ADDENDUM NUMBER THREE
TO THE CONTRACT DOCUMENTS FOR CONSTRUCTION OF
ORANGE BEACH RECREATION COMPLEX
NEW BASEBALL/SOFTBALL FIELD RENOVATIONS AT ORANGE BEACH SPORTSPLEX
CITY OF ORANGE BEACH

This addendum forms a part of the Contract Documents and modifies the Bid Documents dated May 4, 2020.

This Addendum consists of three (3) page Addendum, one (1) general documents, one (1) Specification & thirteen (13) full-size sheets.

DATE 5-04-2020
PAGE 100% BID DOCUMENTS
ADDENDUM #3
PROJECT NO. 3916
SHEET TITLE CONOURSE LEVEL GRANDSTAND - LIFE SAFETY PLANS
DRAWING NO. LS101

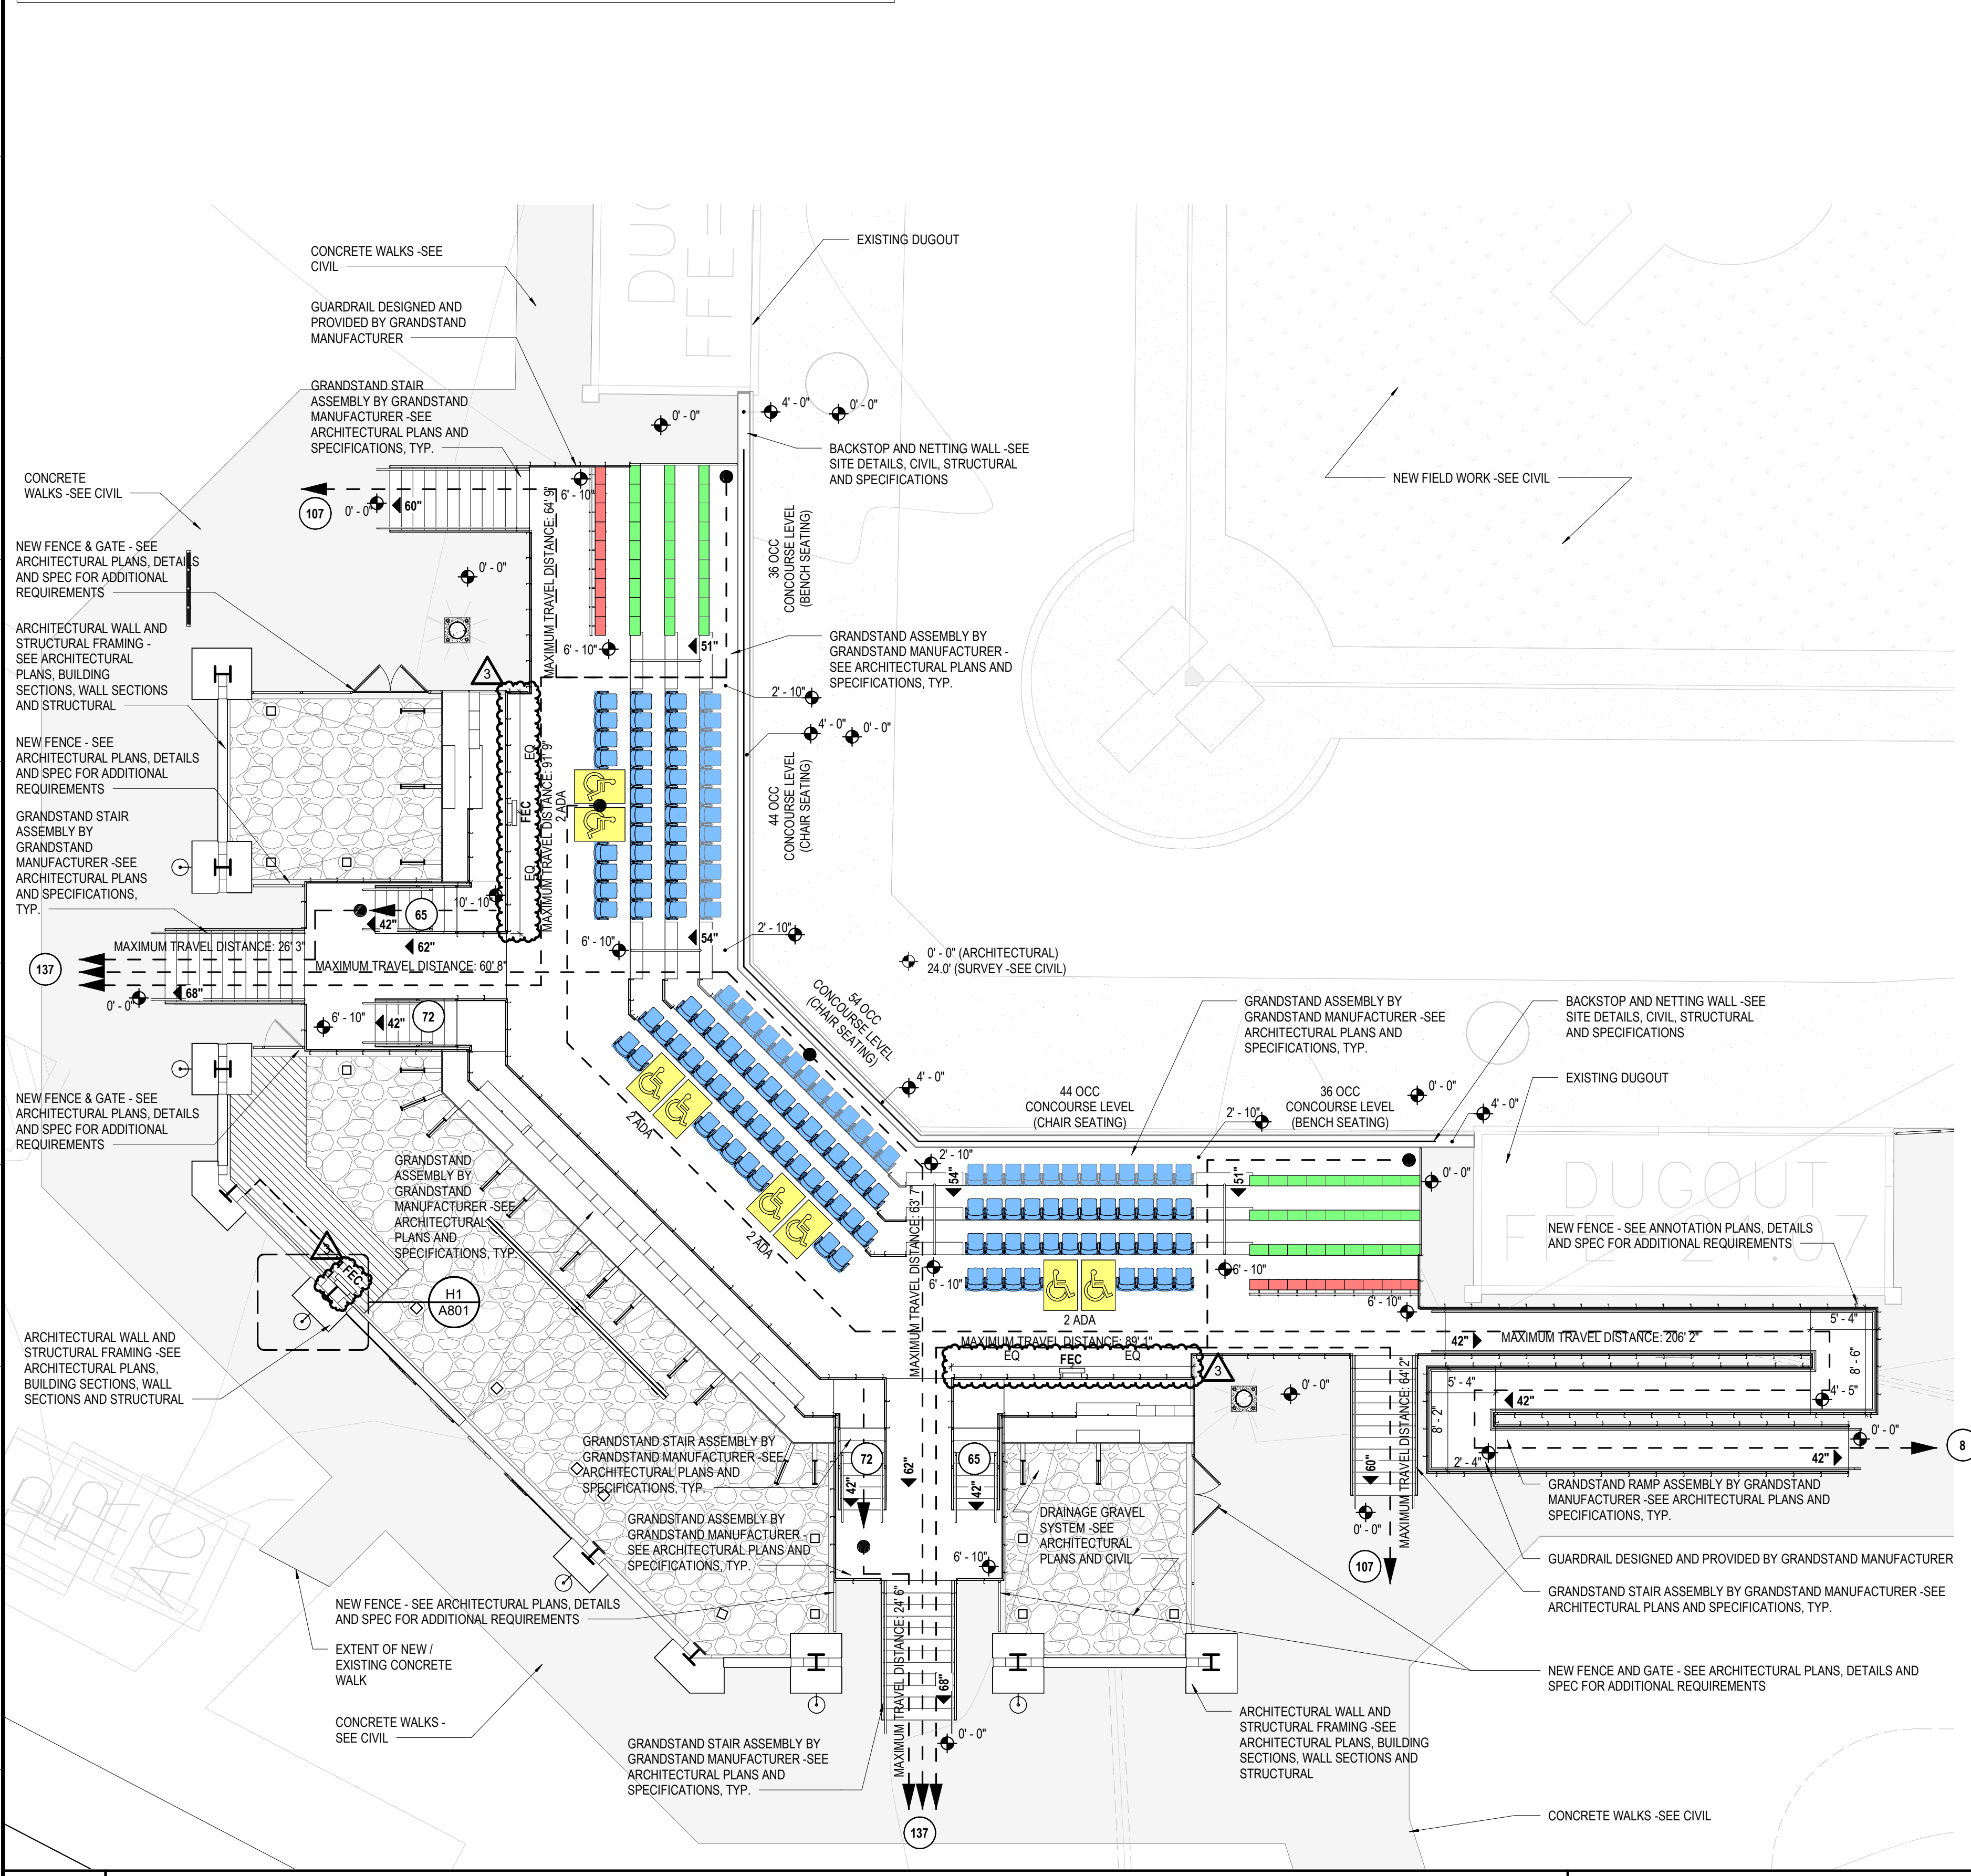
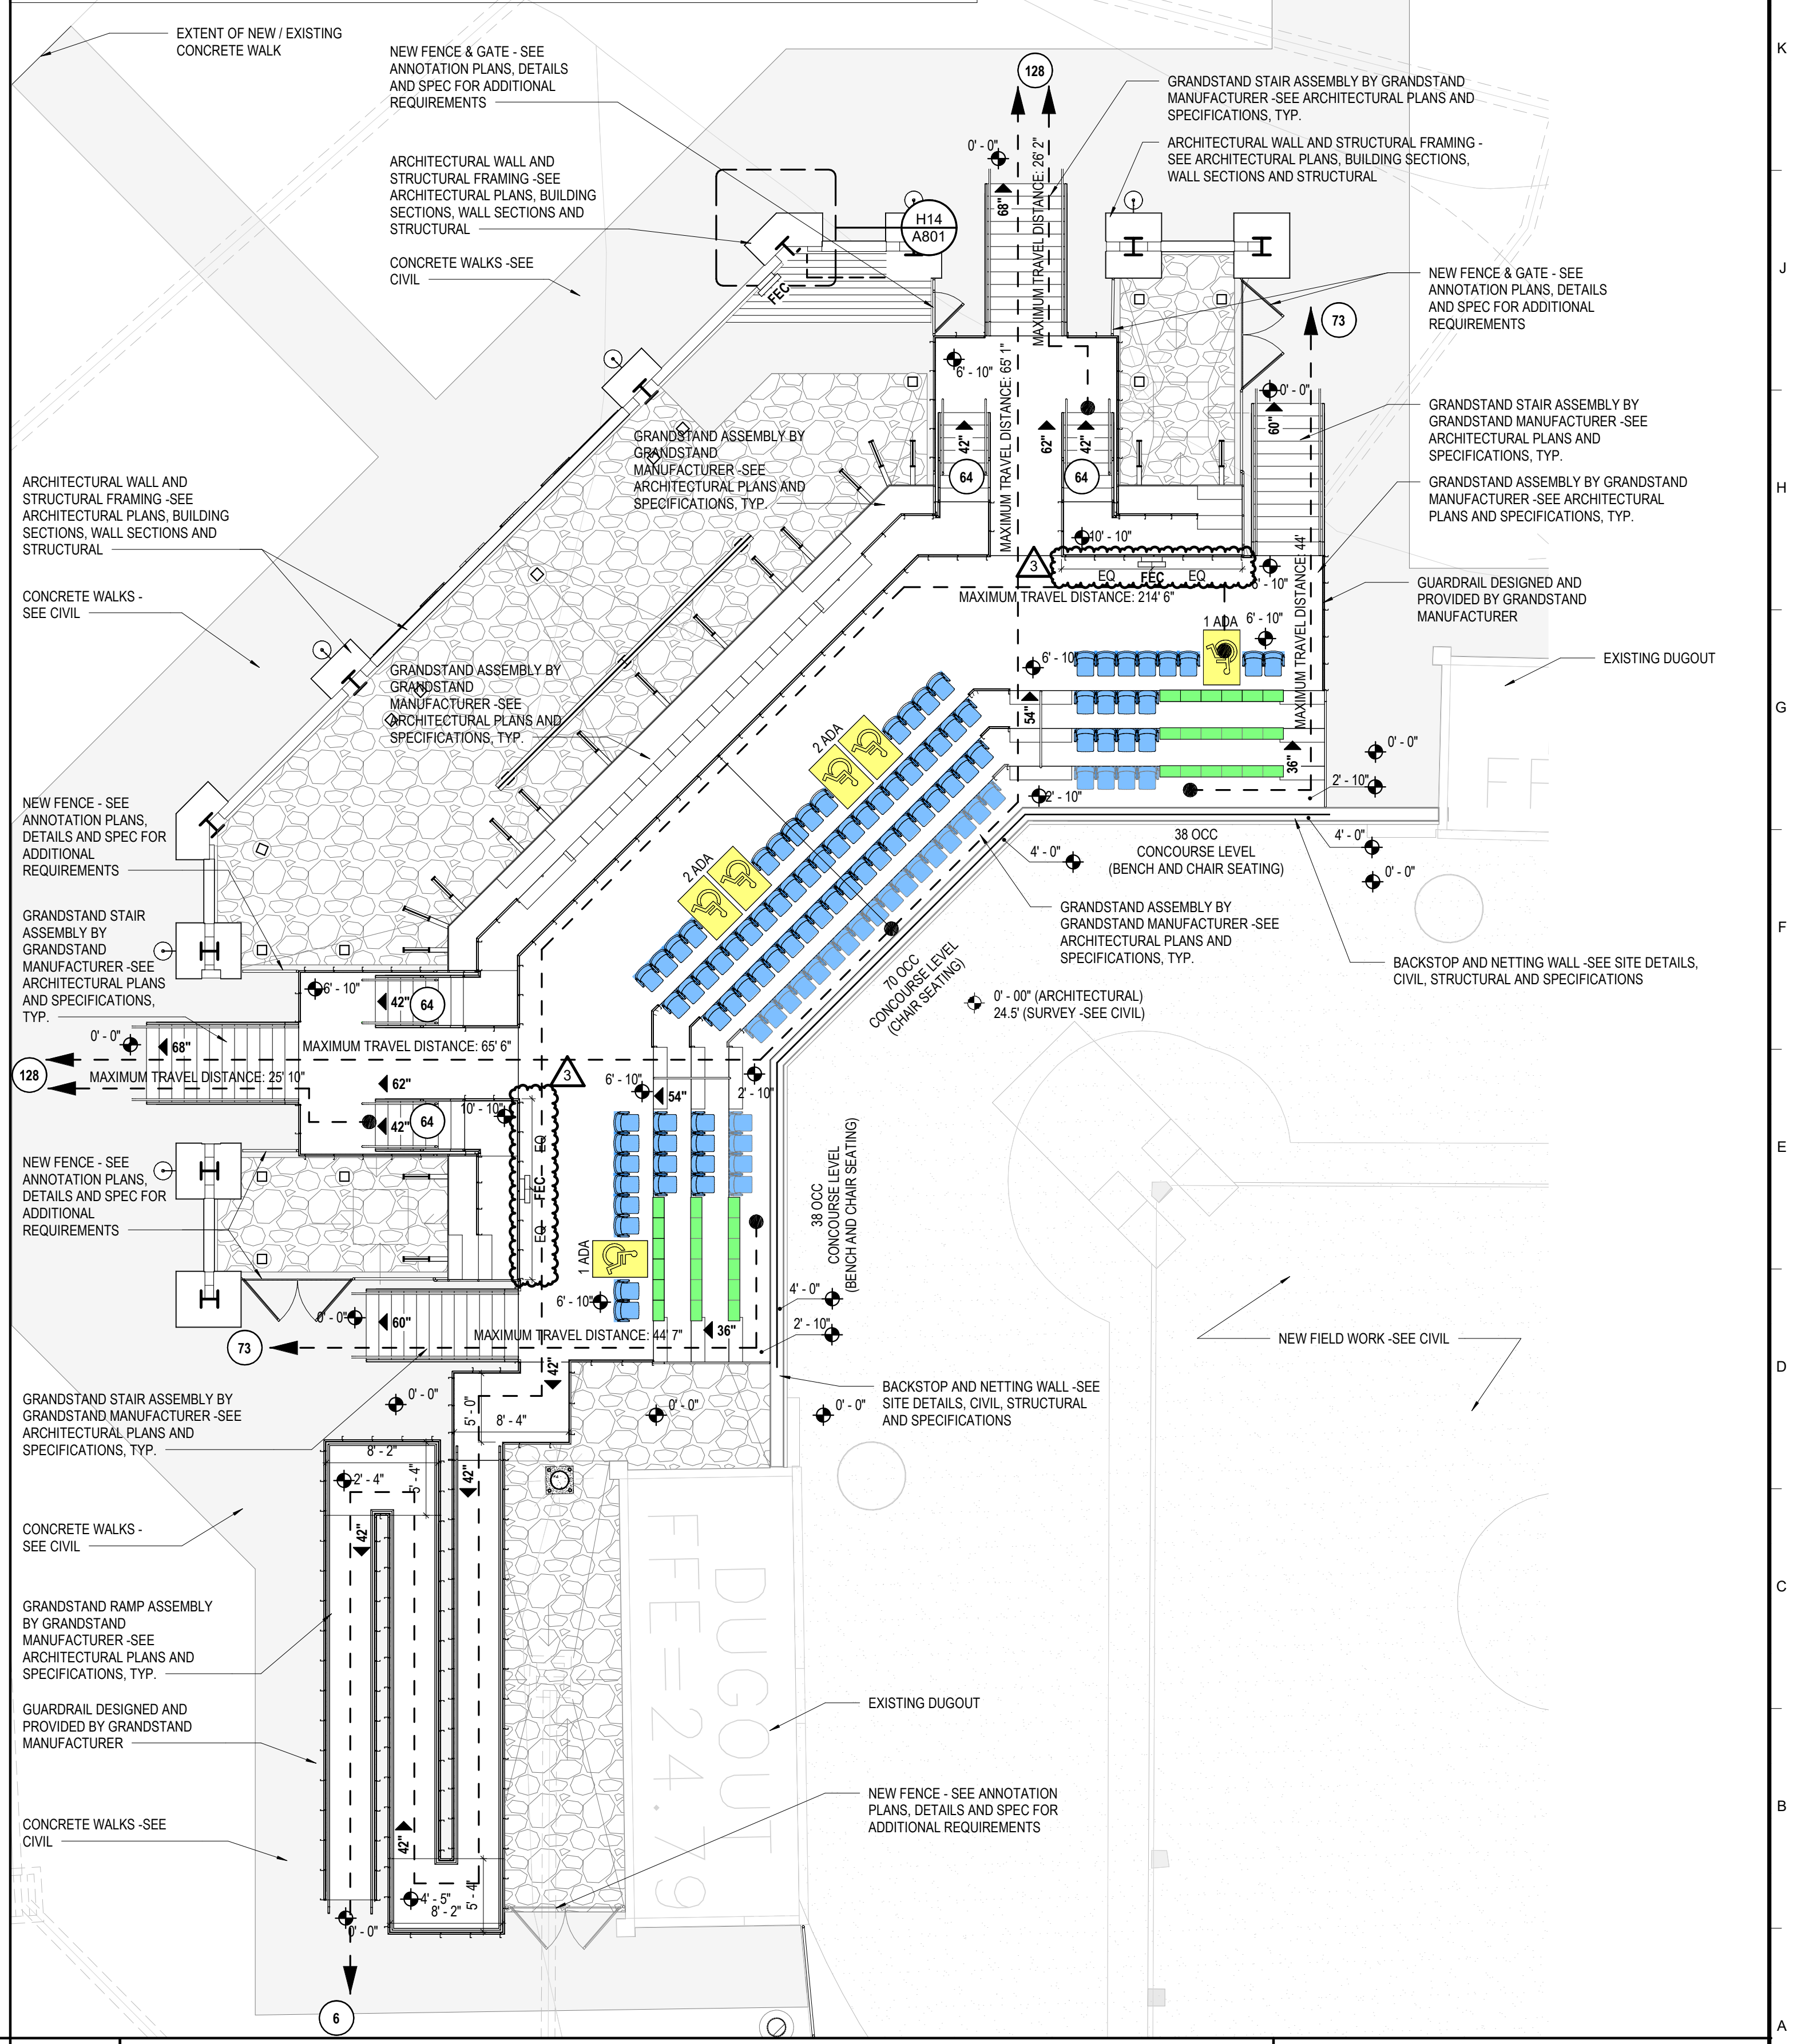
ITEM 06 SHEET LS101 – CONCOURSE LEVEL GRANDSTAND – LIFE SAFETY PLANS

2. Revised Symbols Legend:
 - a. Remove Type C from Legend
 - b. Add Fire Extinguisher Cabinet symbol
3. Added a note to General Notes for additional number of Fire Extinguisher Cabinets to be provided.
4. Added 2 Fire Extinguisher Cabinets w/Fire Extinguishers included on the riser wall of the Grandstand Concourse. Occurs at each Grandstands
5. Replaced 2 Exterior Fire Extinguishers with 2 Fire Extinguisher Cabinets w/Fire Extinguishers included. Occurs at each Grandstands
